PCN # ESW490-47 – Thyristor & Diode SOT-227 Packaging Location Transfer

Product/Process Change Notice (PCN)

PCN#: ESW490-47 **Date:** Feb-07th, 2023

Thyristor & Diode SOT-227 Package Products

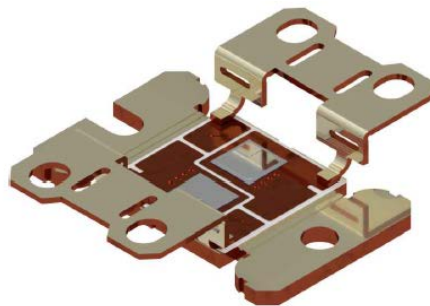
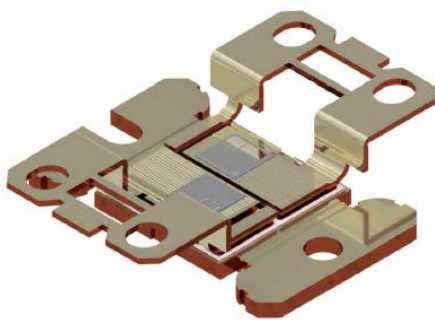
- 1) Small part numbers changed Assy process from Pad type to Padless type. Padless type is widely used for other SOT-227 package part numbers and is considered as a process improvement during the transfer.

Pad Type

Padless type (DCB based Assy)
